PRODUCT CHANGE NOTICE

<b>Notification Date:</b> 9th April 2015	<b>PCN #</b> SIM5055 G PCN 20150409
--	--

**Product Identification:**  
SIM5055-6-1-25-00-A

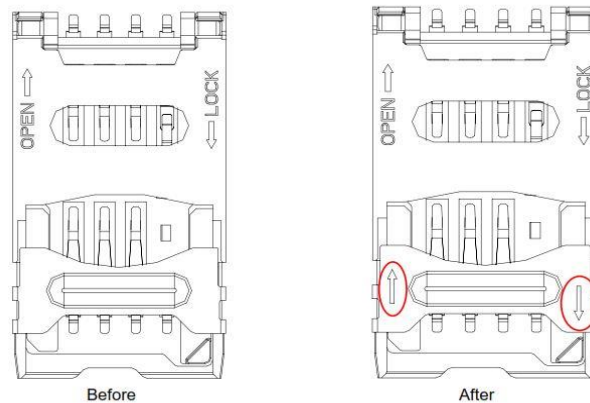
**Description of Changes**

Added arrows on locking metal bar to identify the orientation of locking & unlocking:

**Reason for Change**  
More user friendly in understanding the direction of the unlocking & lock positions.
